**STAFF REPORT FOR CALENDAR ITEM NO.: 14
FOR THE MEETING OF: January 12, 2023**

TRANSBAY JOINT POWERS AUTHORITY

Adopt the Addendum (Addendum) to the Transbay Program 2018 Final Supplemental Environmental Impact Report (SEIR); adopt and incorporate into the Downtown Rail Extension (DTX) Project all of the revisions to four previously adopted mitigation measures as presented in the Addendum; adopt the Revised Mitigation Monitoring and Reporting Program under the California Environmental Quality Act (CEQA); and approve the Revised DTX Project analyzed therein.

Figure 2-2. Approved BART/Muni Pedestrian Connector to be Deferred

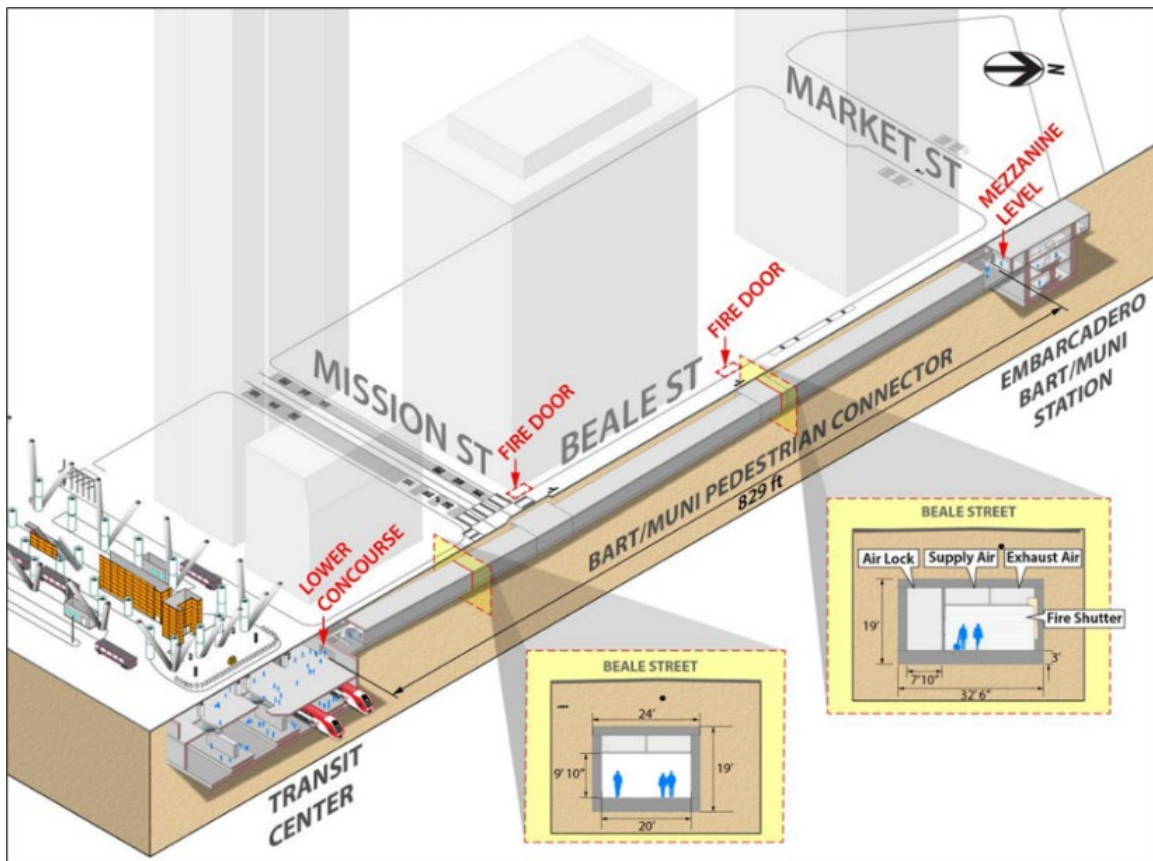
The TJPA would not construct the underground pedestrian connector analyzed in the 2018 Final SEIS/SEIR until station improvements were made at the Embarcadero BART/Muni

Metro Station and the station could accommodate the incoming passengers. Construction of the BART/Muni pedestrian connector could occur in the future and would be coordinated with BART's multi-year, phased-capacity implementation strategy and modernization concept plan for the Embarcadero and Montgomery Stations.

Description and Objective of Proposed Revision. During preparation of the 2020–2021 Transbay Program Downtown Rail Extension Phasing Study (TJPA 2021), BART staff sent a letter to the TJPA expressing no objection to the deferral of the pedestrian connector, because BART's evaluation of the Embarcadero BART/Muni Metro Station capacity was in progress. BART conducted planning work on potential options to resolve (pre-pandemic) overcrowding issues at the Embarcadero BART/Muni Metro Station, which would involve station platform modifications, and therefore would affect the approved pedestrian connector. Also, BART, in partnership with the Capitol Corridor Joint Powers Authority, has begun studying a regional rail connection from the East Bay (known as Link21) that may include a station in San Francisco to address these capacity issues. BART indicates that the studies and possible station and transbay crossing concepts will be evaluated pursuant to NEPA and CEQA approximately in the 2024–2027 timeframe. Deferral of the pedestrian connector would allow BART to develop a plan to incorporate a pedestrian connection in concert with capacity-enhancing station modifications at the Embarcadero BART/Muni Metro Station.

Figure 2-3. Proposed Reduced Train Box Extension

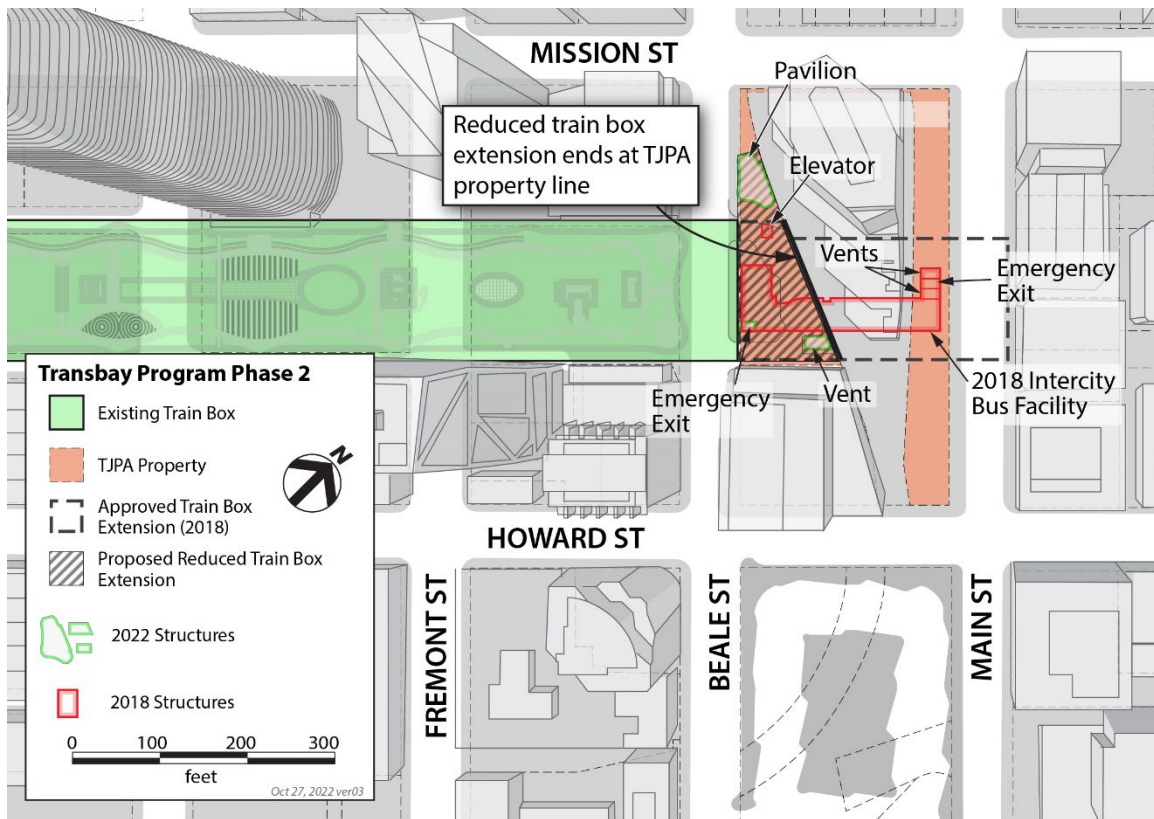
Therefore, the TJPA proposes to reduce the extension of the train box that was approved in the 2018 Final SEIS/EIR by approximately 250 feet (Figure 2-3). With this reduction, the train box extension would end at the TJPA property line just east of Beale Street. As a

result of this reduction, no land acquisition would be required for this project component, and demolition of the lower podium portion of the building at 201 Mission Street would not occur. As part of the reduction, the vent structure and emergency exit that had been approved as part of the extended train box at the Transit Center would be relocated to the TJPA parcel just east of Beale Street across from the Transit Center as shown in Figure 2-3.

In addition, the approved intercity bus facility would have provided access to the Transit Center station below. With the deferral of this facility, a new street-level entrance/exit pavilion to the Transit Center would be constructed on the TJPA parcel along Beale Street, immediately north of the site for the intercity bus facility, as shown in Figure 2-3.

Figure 2-4. Approved Intercity Bus Facility

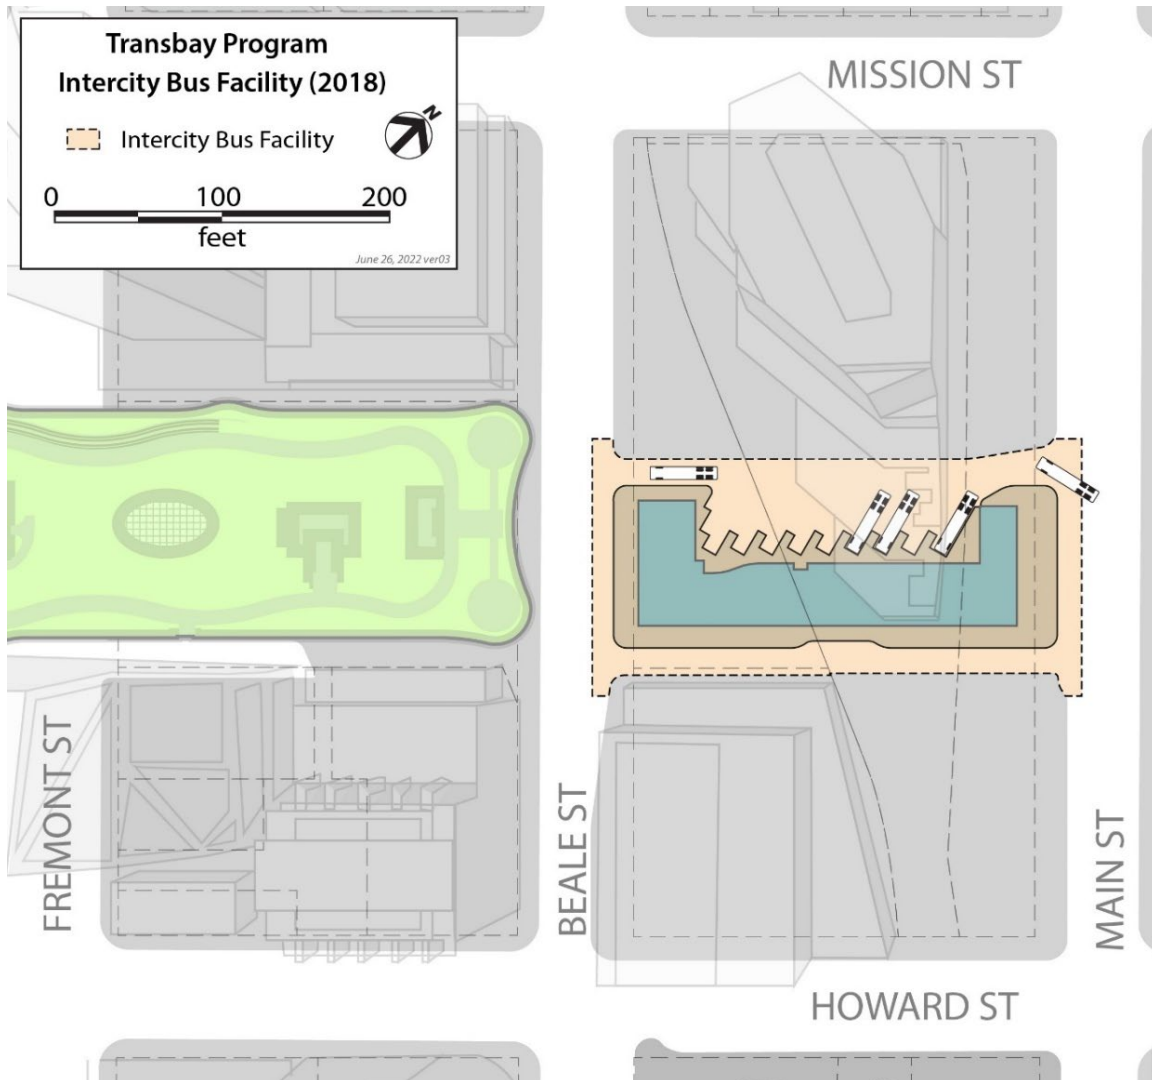
Approved Project. The approved intercity bus facility evaluated in the 2018 Final SEIS/EIR would be constructed at street level above the extended train box to accommodate regional and long-haul bus operators, such as Greyhound and Amtrak. The intercity bus facility would accommodate shuttle services and bus operations, and would expand and enhance the Transit Center’s inter- and intra-regional transit linkages by connecting with the two below-ground levels of the Transit Center. Located behind the 201 Mission Street building (south side), the intercity bus facility would include 10 bus bays dedicated to regional bus services and two floors of office or residential space.

The intercity bus facility, shown in Figure 2-4, would be constructed across the street from the east end of the Transit Center. Buses would enter the intercity bus facility from Main Street and exit onto Beale Street. The facility would be dedicated to regional bus services, some of which currently operate from the Transit Center’s bus deck under lease agreements with AC Transit, the master lease holder of the bus deck.

Description and Objective of Proposed Revision. AC Transit anticipates that it will need to expand its use of the bus deck between 2035 and 2050. Currently, AC Transit leases two bus bays to Greyhound, with shared use of a third bay and an additional bus bay leased to WestCAT. Greyhound has a separate lease agreement with the TJPA for approximately 4,500 square feet of the Transit Center, for its office/ticketing area, package express operations, and passenger waiting area. Both of Greyhound's lease agreements will expire on August 31, 2029.

Figure 2-5. Approved Taxi Staging Area at the Intercity Bus Facility to be Removed

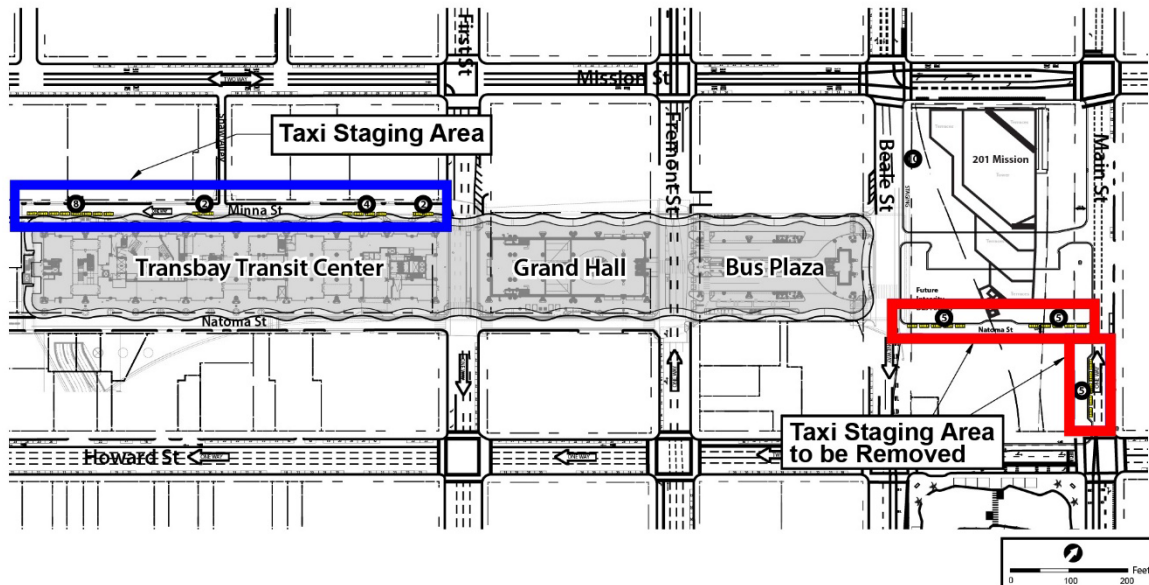
Approved Project. The approved project evaluated in the 2018 Final SEIS/EIR includes a taxi staging area at the intercity bus facility to provide taxi services to passengers at the intercity bus facility and persons exiting the Transit Center at Beale Street. The approved taxi staging area would be located along the north side of New Natoma Street between Beale and Main Streets and along the west side of Main Street between Natoma and Howard Streets, with a pick-up area on the south side of the intercity bus facility. The location of this taxi staging area is shown on the right side of Figure 2-5.

Description and Objective of Proposed Revision. Because of the deferral of the intercity bus facility and the reduced size of a future intercity bus facility as described above, no space would be available for a taxi staging area a smaller intercity bus facility. In addition, a taxi staging already is adjacent to the Grand Hall on Minna and Natoma Streets. Further, an increasing percentage of vehicle trips are performed by Transportation Network Companies that provide alternative taxi type service at designated pickup and drop off areas along Mission Street and Howard Street, around the Transit Center. Therefore, the Revised Project would remove the approved taxi staging area at the intercity bus facility.

Figure 2-6. Approved Three-Track Tunnel Segment to be Converted to Two Tracks

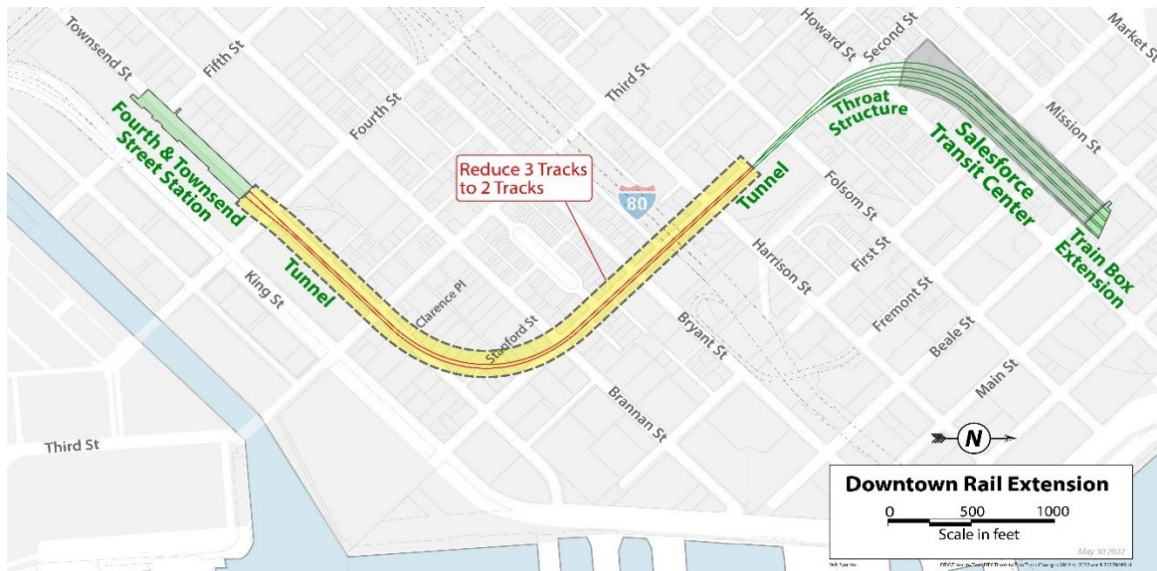
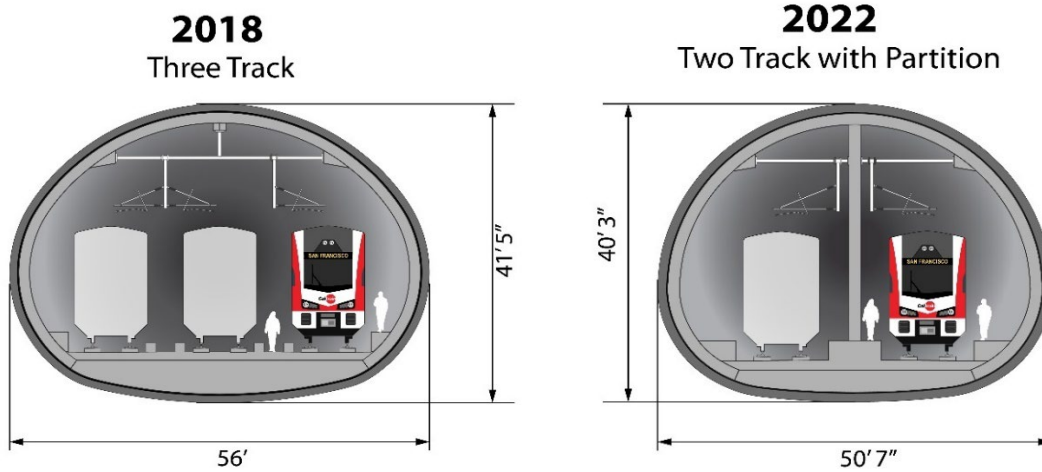
Description and Objective of Proposed Revision. An updated operations analysis was conducted as part of the phasing study analysis in 2020, conducted by Deutsche Bahn International on behalf of Caltrain and CHSRA, to validate infrastructure requirements as new information regarding the rail operators' vehicles and operating plans were defined, and to determine whether the track configuration could be optimized to enhance rail service and/or result in reduced project costs. As part of this updated operations analysis, a longer two-track section and reduced three-track section in the tunnel were recommended, together with a proposed modification of the Fourth and Townsend Street Station design (described next).

In this configuration, the three-track section of the tunnel that would be reduced to two tracks would begin mid-way between Harrison and Folsom Streets along Second Street, continue south along Second Street, and then east along Townsend Street to Fourth Street (Figure 2-6). Approximately 3,900 feet of the approved three-track configuration in the tunnel would be replaced with two tracks as part of this proposed change in design. The width of tunnel for this 3,900-foot segment would decrease from 56 feet wide to less than 51 feet wide, which also would reduce the permanent easement width in this segment (Figure 2-7). The amount of excavation also would decrease by 67,000 cubic yards because of the reduced tunnel width in this segment.

The reduced three-track segment within the tunnel would not change the throat structure that was approved in 2018. The updated operations analysis indicated that the reduced three-track segment of the tunnel would result in on-time operational performance, consistent with operators' established service standards. This reduction in the three-track section is made possible because of the improved performance of the Caltrain vehicle type and technology (i.e., electric multiple units that are self-propelled vehicles using electricity) from that previously assumed, and the modification of the Fourth and Townsend Station, as described below.
